MJC site visit

Tuesday, 11 July 2023

Client ATG

32 Scope Identified

LOCATION REF 1

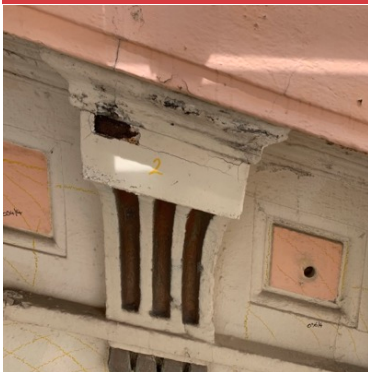
Replace restraint strap

LOCATION REF 2

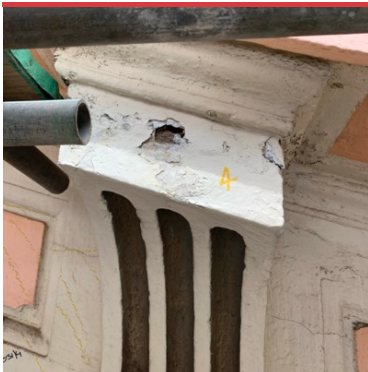
Replace restraint strap

LOCATION REF 5

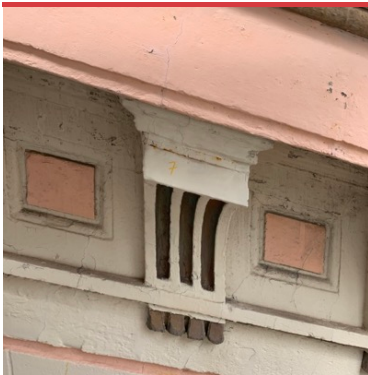
Replace restraint strap

LOCATION REF 8

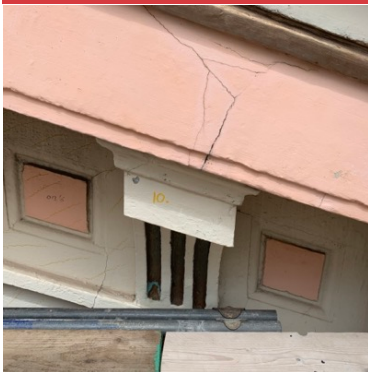
Replace restraint strap

LOCATION REF 10

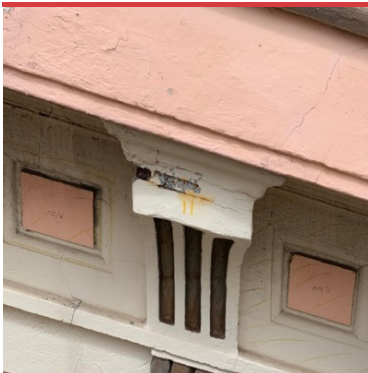
Treat restraint strap

LOCATION REF 17

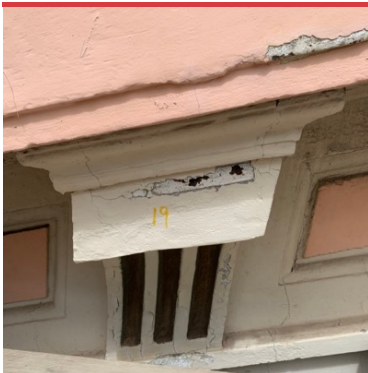
Potentially replace , treat as minimum

LOCATION REF 29

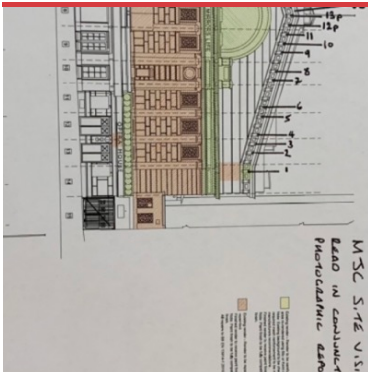
Helifix bars required under W8 to next window, red lines rough annotation under we receive MJC detail.
